GROUNDWATER REMEDIAL ACTION OPTIONS MEMORANDUM ADDENDUM

May 6, 2021

Re: Technical Memorandum Addendum – Groundwater Remedial Action Options / Interim
Remedial Action Plan
Former Navistar/RMG Foundry - 1401 Perkins Avenue, Waukesha, WI
BRRTS # 02-68-098404

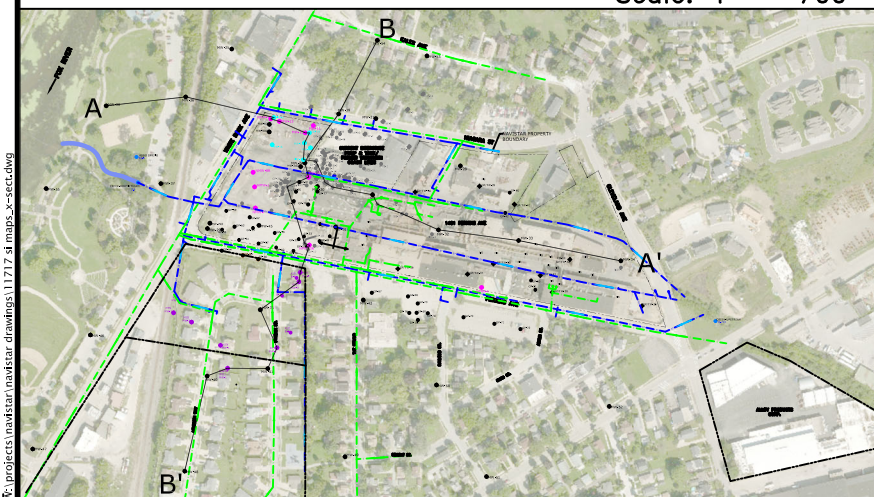
2. The proposal and evaluation of data should be supported by figures and cross sections. Cross sections should identify unconsolidated material, bedrock (and competency observations if available), water table depth, well screen depths, recent groundwater concentrations, and ground surface. Figures should identify monitoring wells to be used in the injection monitoring. Provide at least one figure with groundwater data for all these wells over the last year, to support evaluation of pilot test impacts.

New cross sections have been created to provide the above listed information. The existing site cross sections already show the stratigraphy of the site, water table depth, well screen depths, and the ground surface. The cross sections A-A' and B-B' provided in Attachment A include the groundwater concentrations for TCE from March/April 2020 through December 2020. A figure is

PROPOSED GROUNDWATER INJECTION GRID AND INJECTION POINTS

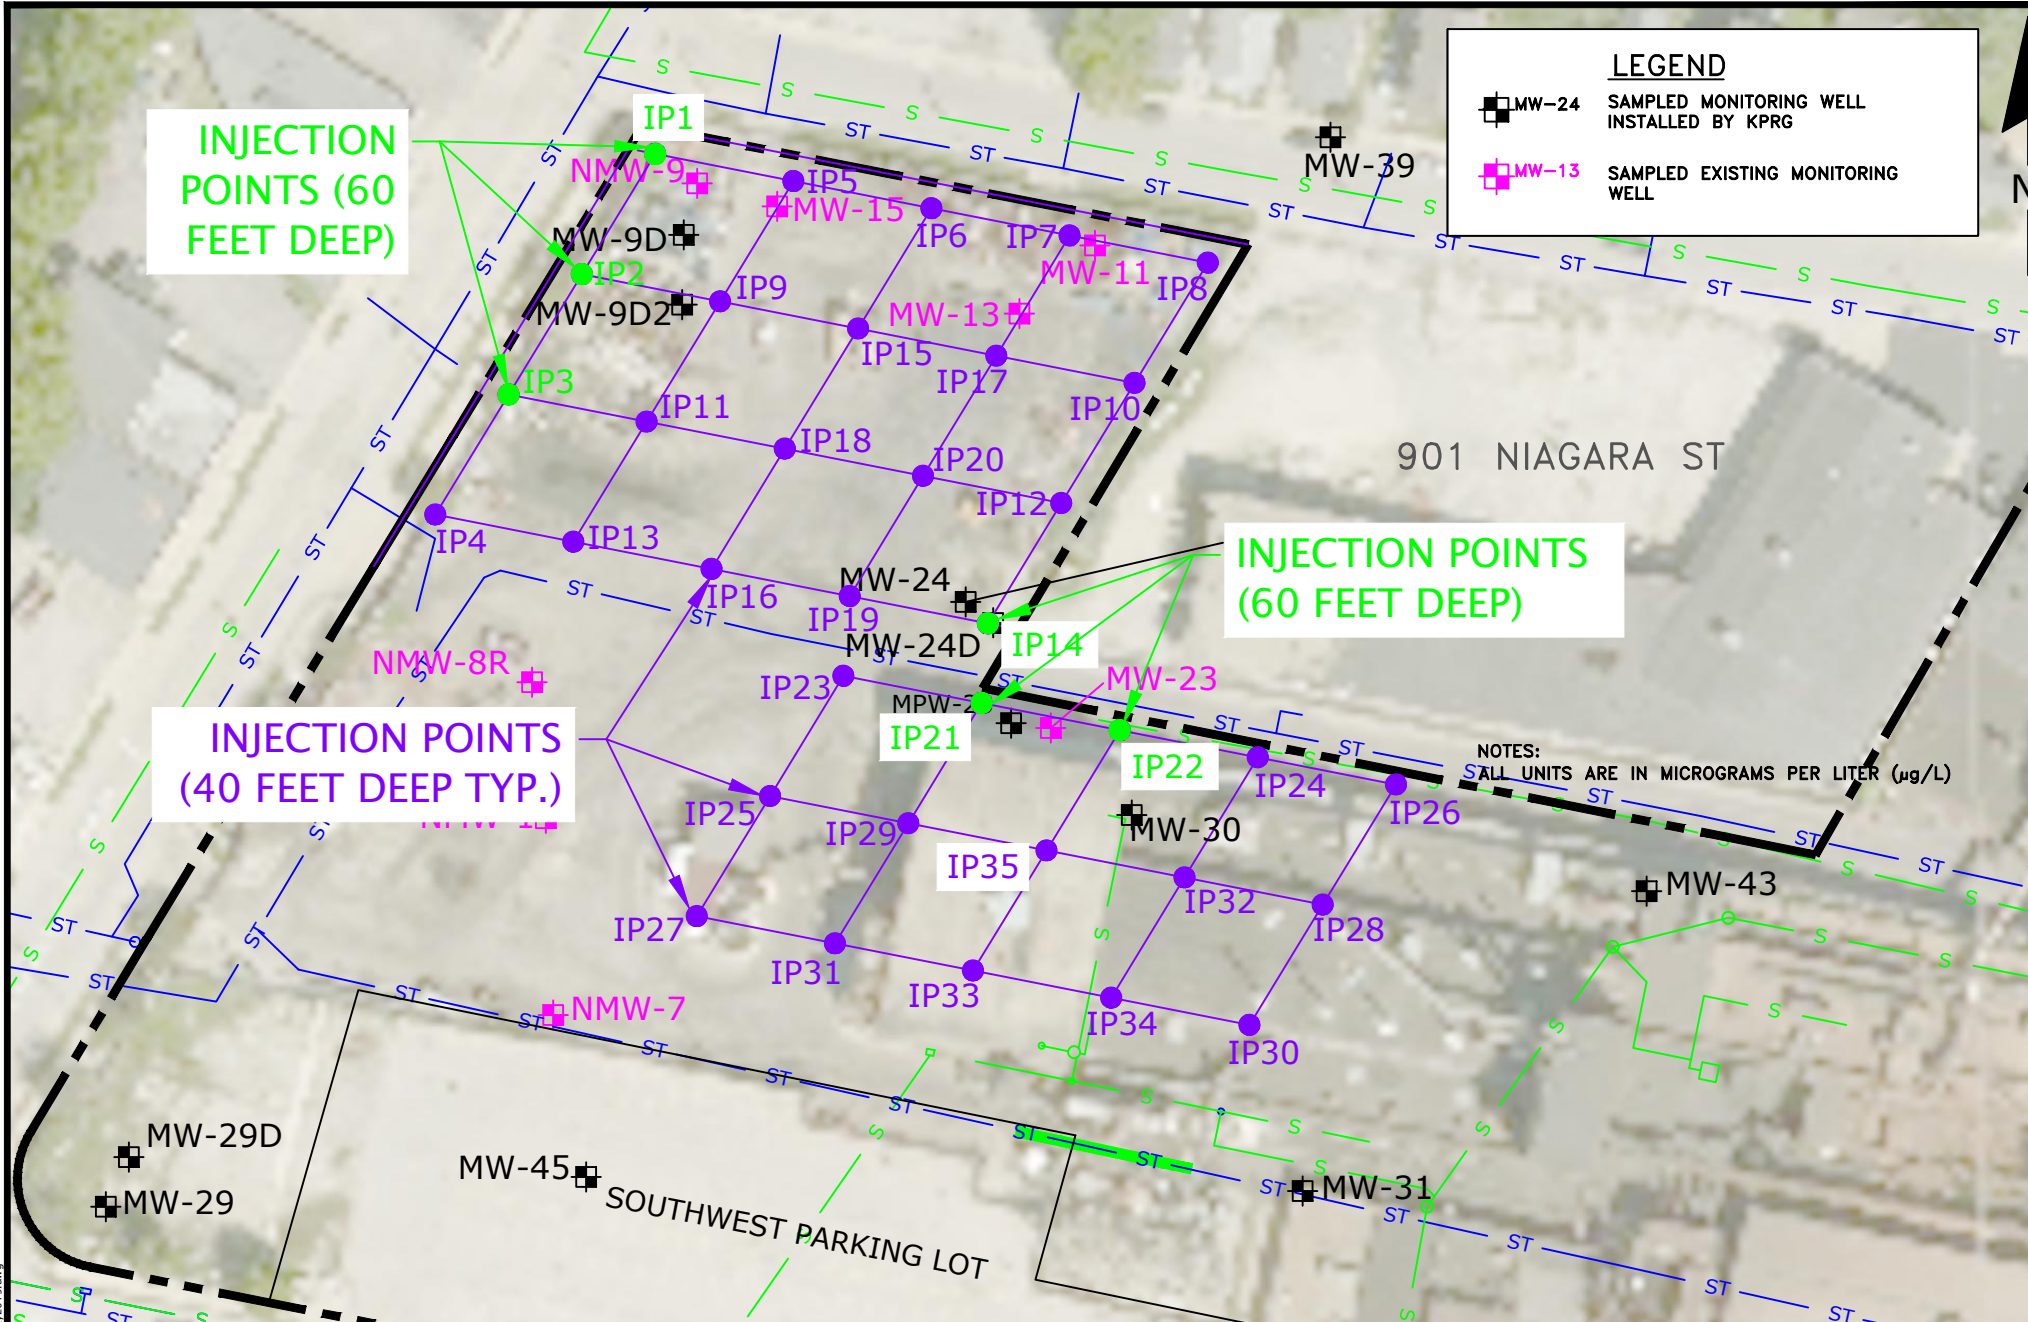
3. Provide a detailed description of injection plan, including timing and progression plan for injections and how this will be monitored to ensure plume expansion is not being caused. Identify potential receptors in the path of possible plume expansion and any potential impacts to be monitored.

There will be thirty-five (35) points of injection total. Twenty-nine (29) injection points will be installed as 3"-4" diameter open boreholes with a target injection range of 20 ft to 40 ft bgs. Six (6) injection points will be installed as 6" diameter open boreholes with a target injection range of 20 ft to 60 ft bgs. Figure 4 that was previously provided in the GW RAOR was updated to include the proposed numbered order in which the injections will be performed. It may be necessary to alter this order based on field conditions that may arise. This revised Figure 4 is provided in Attachment B.

The injection sequencing will start from the farthest down gradient perimeter of the injectate grid (Fig. 4), with subsequent injections gradually moving towards the east end of the injection area. By ordering the injections from the outer perimeter of the treatment area and then inwards, the potential for mobilizing contaminant offsite is minimized. The location of the injection points in the northwest will also address any contaminant that may have been pushed as part of the pilot test, which was discussed in Section 2.2.2. In addition, locating the injection points on the edge of the 300 µg/L contour and in some cases beyond will also address some of the contaminants within the 200 µg/L contour because the pressure of the injection will move the injectate into this area and any groundwater flow will carry the injectate.

As previously noted above in this response, the referenced Figure 4 in the italics text provided from the original submittal has been revised to include an injection point sequencing numbering. That revised Figure 4 is provided in Attachment B.
